September 6, 2005

WM-110

**Subject:** Response to the Request for Additional Information on "Field Procedures for the Radiological Excavation Control and Radiological Verification of the Moab Project Site"

Decision Tree for Interior and Exterior

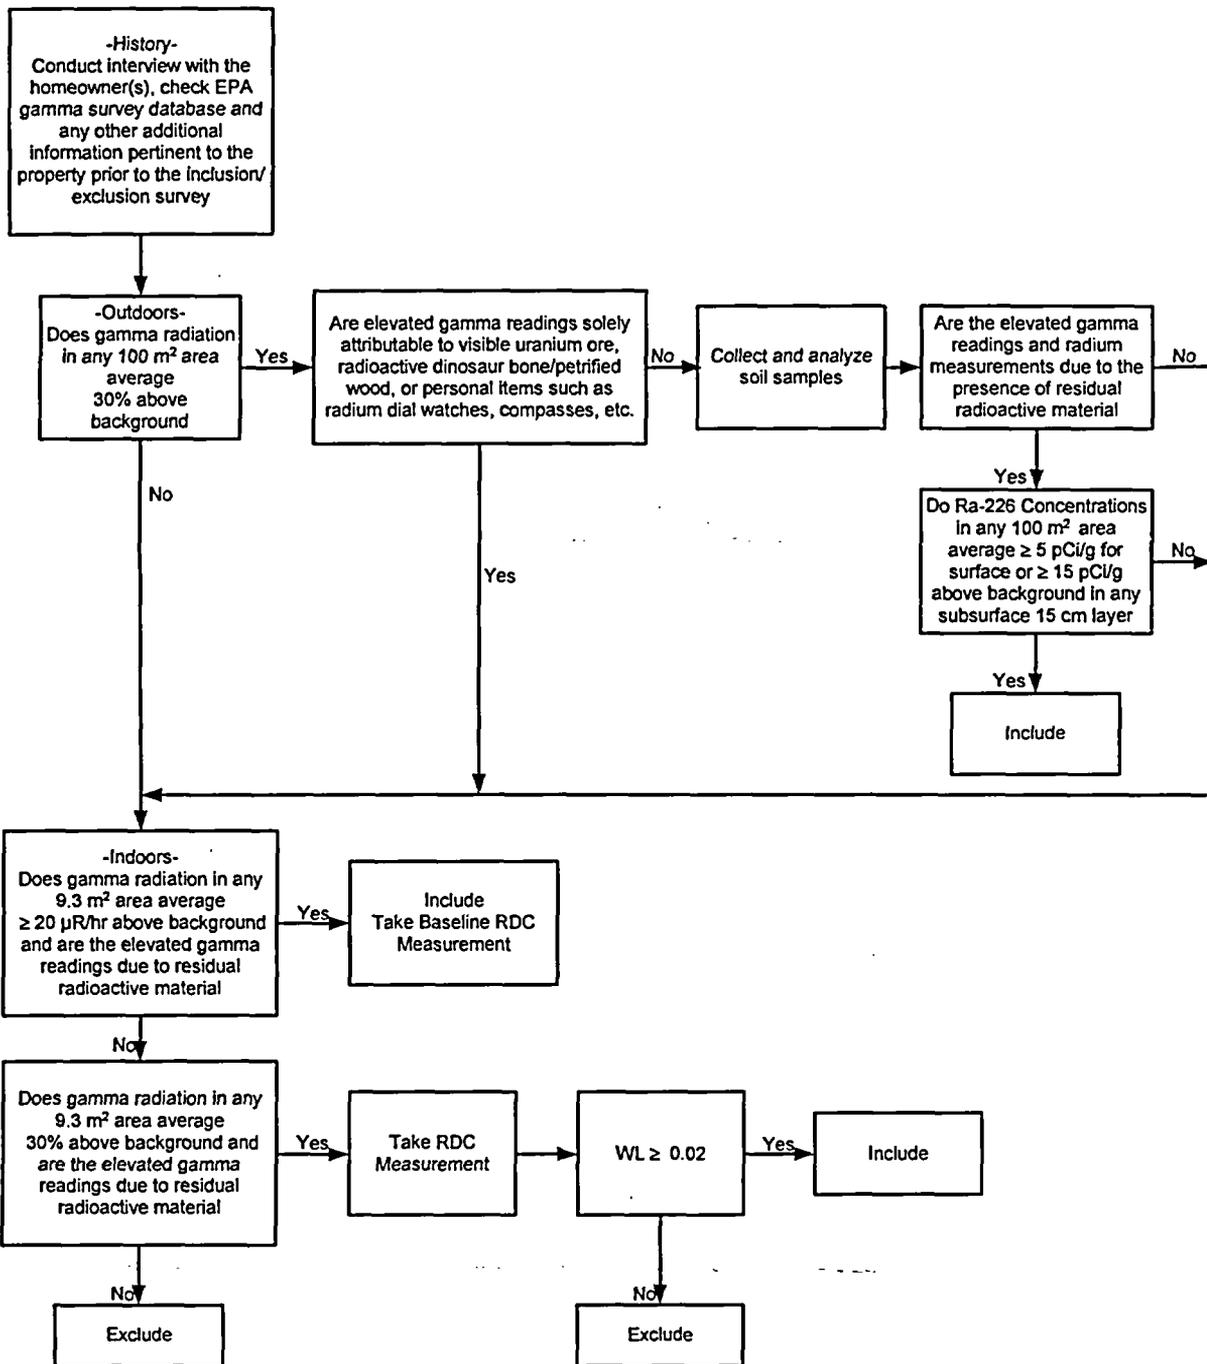
### Attachment 1, Page 4, Section 2.4

The inclusion/exclusion survey decision tree (enclosed) and associated text in Attachment 1 will be revised to correct the inconsistency for initiating soil sampling for inclusion purposes when the gamma exposure rate is 30-percent above background (1.3 times background) averaged over a 100 square meter area. This change should address concerns of buried tailings deposits that might have been missed using the 25  $\mu$ R/h above background criterion.
